OSA -0599-68

7 February 1968

Subject: LOCAL MODIFICATION TO P/N DN55000 PARACHUTE

ENVELOPE # 6115-2
NEG. NO. 18414
DATE SHOT DEC 14 1966
DATE RECEIVED DEC 14 1967
ORDERED BY [REDACTED]

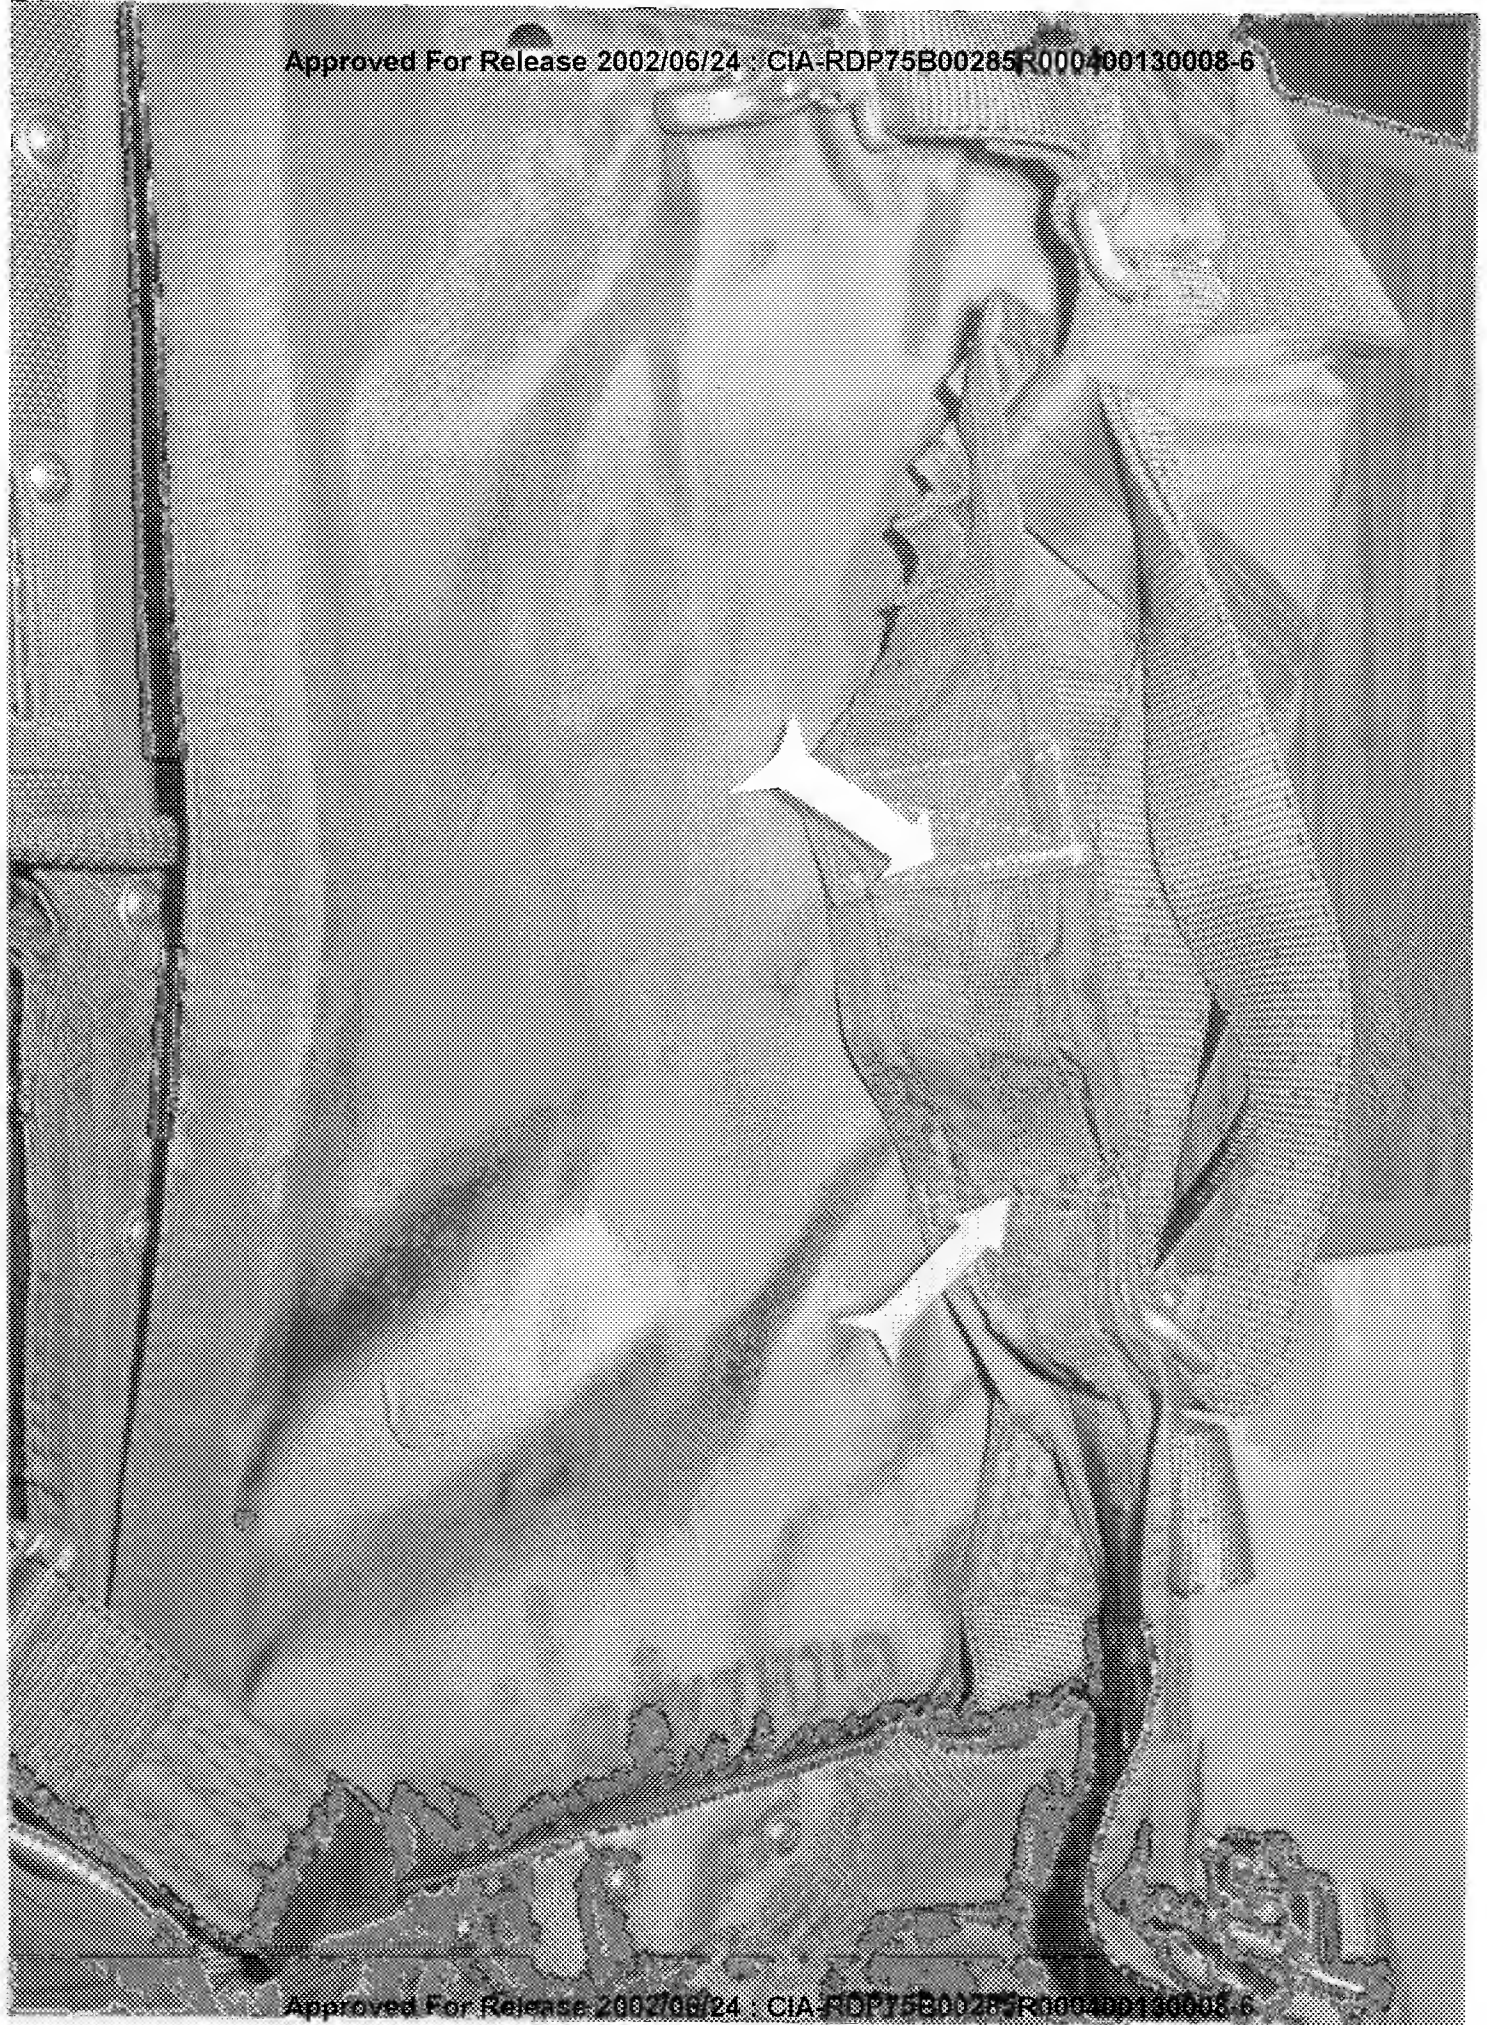
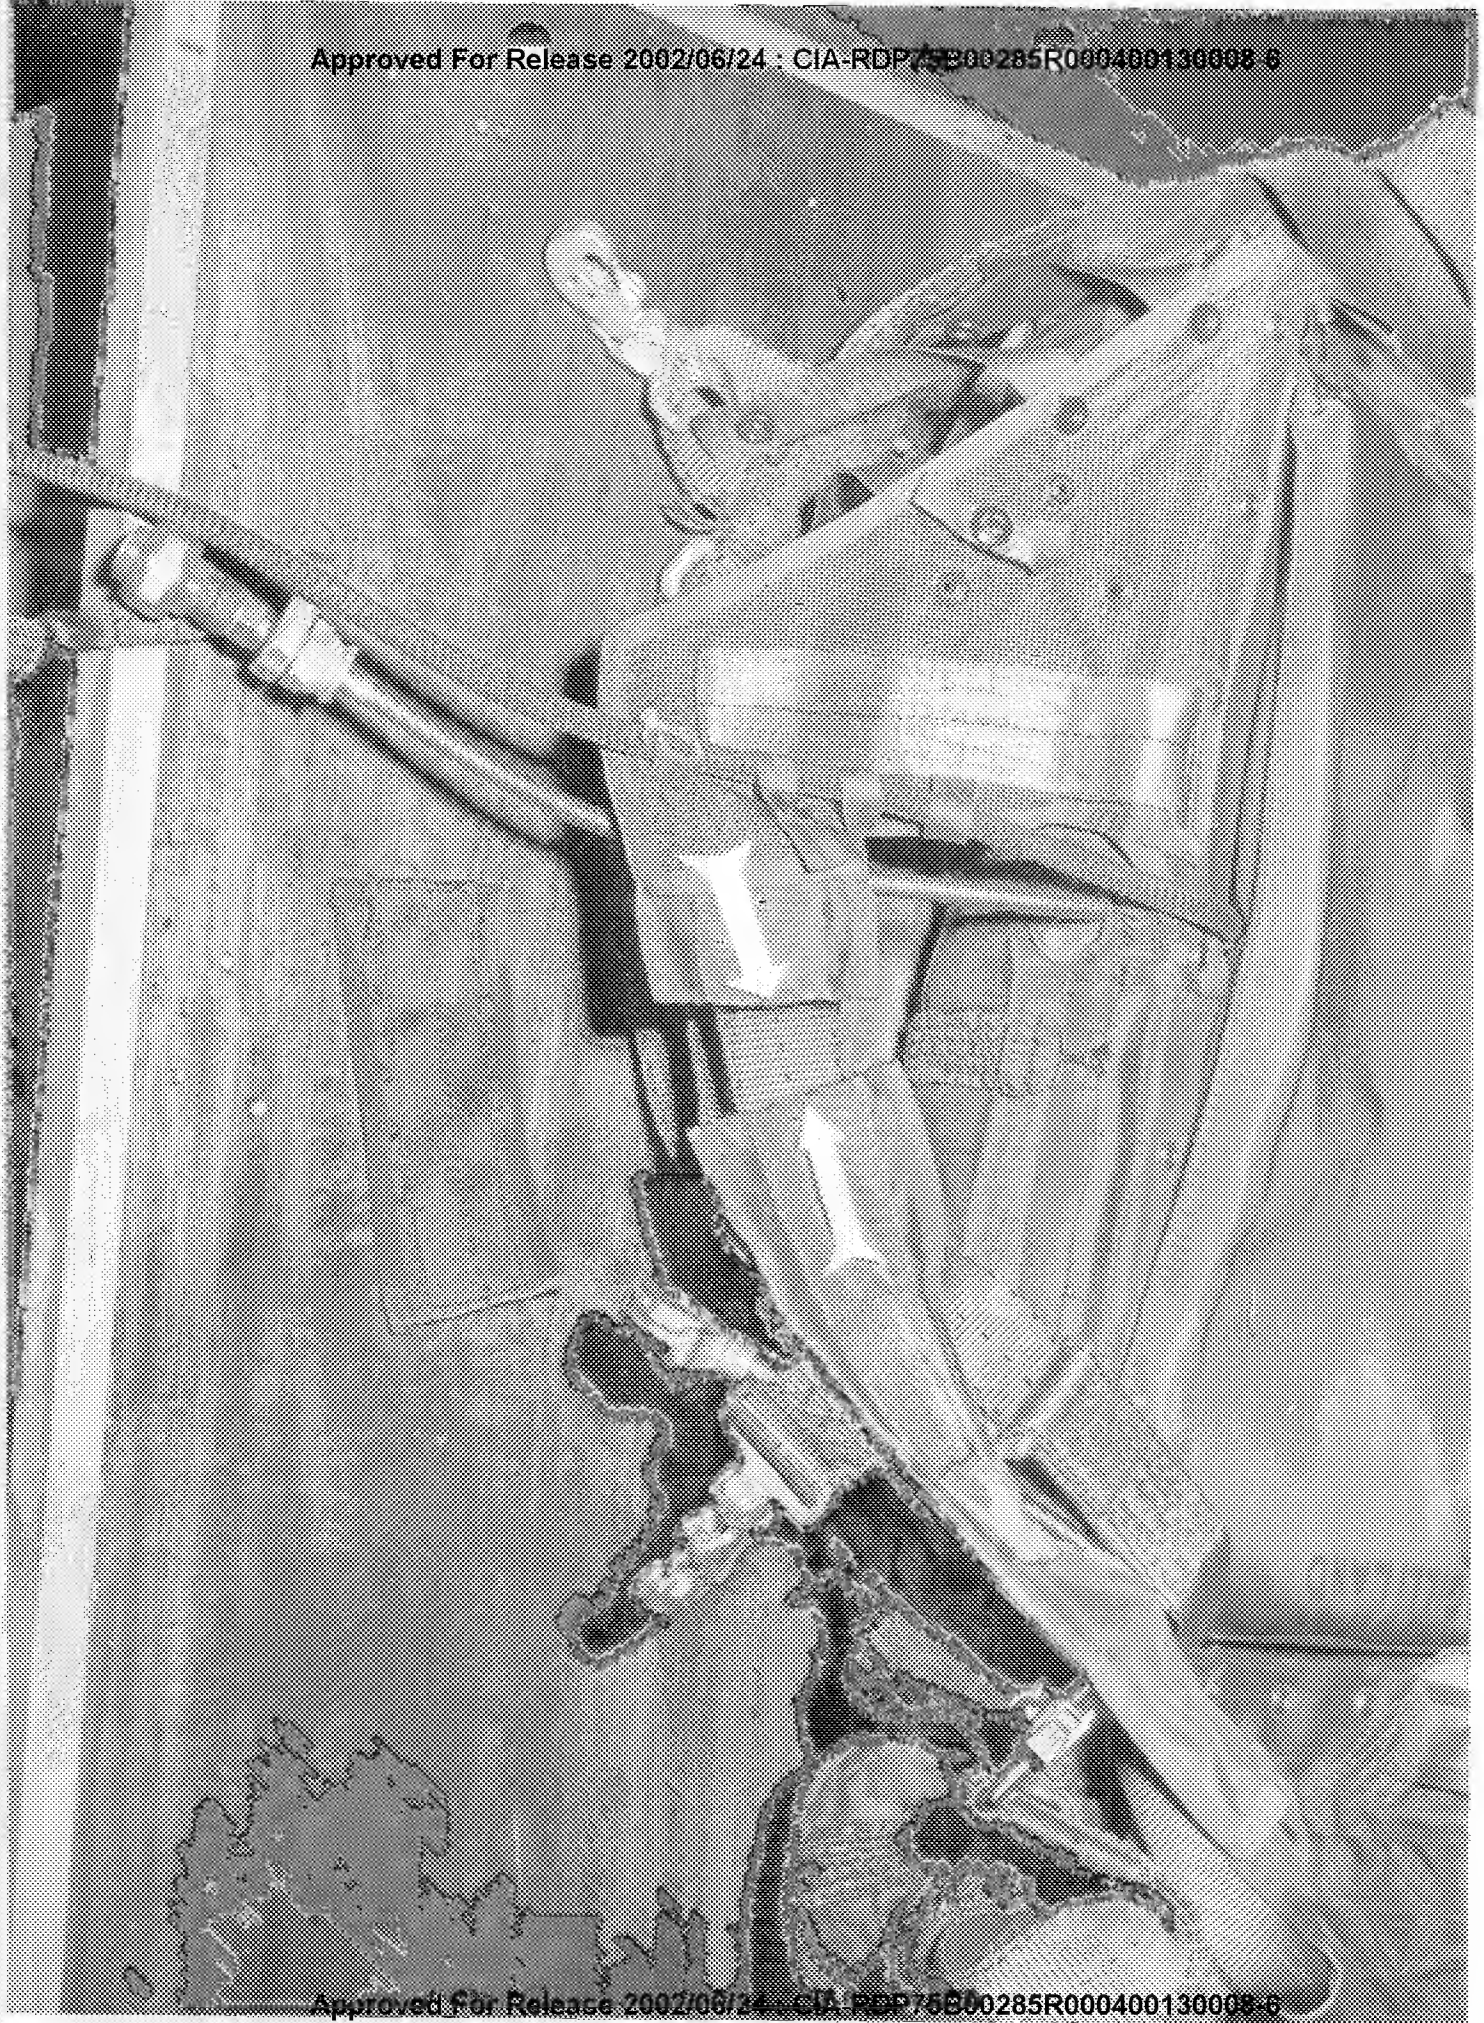
Enclosed photos show a modification incorporated to one DN55000 Parachute, by BW-4 personnel.

The modification consists of a four-inch extension to the non-structural fabric beneath the two vertical lift webs.

This modification was required in order to permit length adjustment of the lift webbing on pilot [REDACTED]

Prior to the modification, the fabric limited the harness length adjustment and put intolerable pressure on Bob's shoulders.
